**ADDITIONAL INFORMATION**

**SDCC Ref: SD21A/0347 – Paint Workshop Extension with Canopy**

**Galco House, Ballymount Road, Walkinstown, Dublin 12**

**19<sup>th</sup> April 2022**

Fig. 1: Extract from SDCC Development Plan Zoning Map 2016-2022 showing 'long-term road proposal traversing the Galco Steel site'.

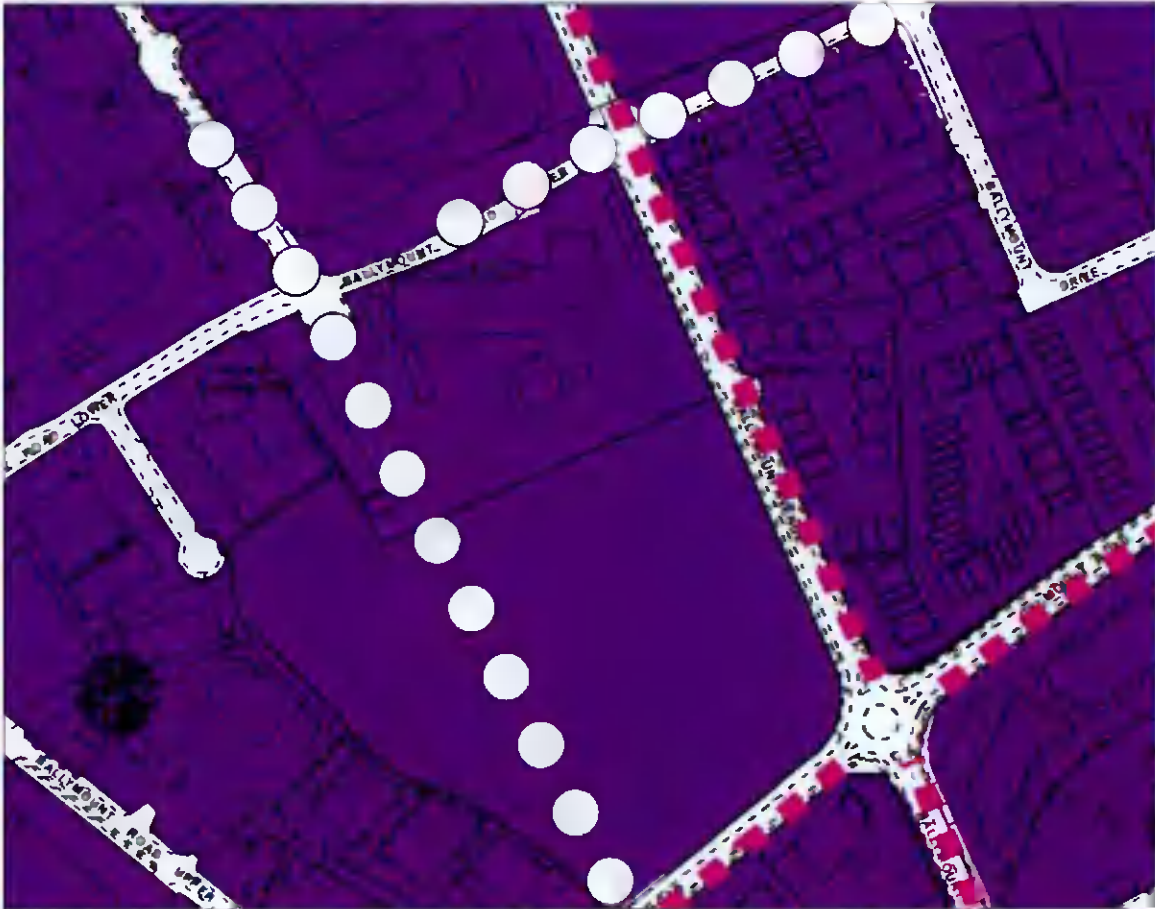
*Having regard to the 'EE' zoning objective of the site, it is considered that the subject land use is acceptable in principle. However, within the current South Dublin County Council Development Plan, the application site along with the wider landholding is identified for the delivery of a long-term road proposal for the southern extension of the Merrywell Industrial Estate Road. In this regard, the applicant is requested to demonstrate that the proposed development would not prejudice the future delivery of the identified road extension. It is noted that this may require revisions to the design as currently proposed.*

*Prior to responding to the Additional Information request, the applicant is advised to liaise with the Roads Department of South Dublin County Council.*

We note that the 'long-term' road proposal for the southern extension of the Merrywell Industrial Estate is shown traversing the Galco Steel site in a north-south direction, in line with the entrance to the Merrywell Industrial Estate and the Galco Steel entrance to the north, as per the extract from the Council's Development Plan Policies Map 2016-2022 in Fig. 1 below:

We note that this road proposal was first shown in its current form on the previous iteration of the South Dublin County Council Development Plan, 2010-2016. We note that the Draft County Development Plan also identifies this aspirational future road.

The applicant has concern about the location of this aspirational road which impacts not just the safe and efficient operation and future development potential of our client's lands, but indeed the viability of continued operations on the site. Over 100 HGVs per day use the existing entrance, supplying building sites across the country. The land within and surrounding the path of the road proposal is integral to the operation of the galvanising plant on site, with vehicle movements as well as the storage and manoeuvring of large steel components utilising the space between existing buildings on site where the road is proposed to run. The applicant would strongly resist any attempt to deliver this 'road proposal' due to the effect on their interests at this location.
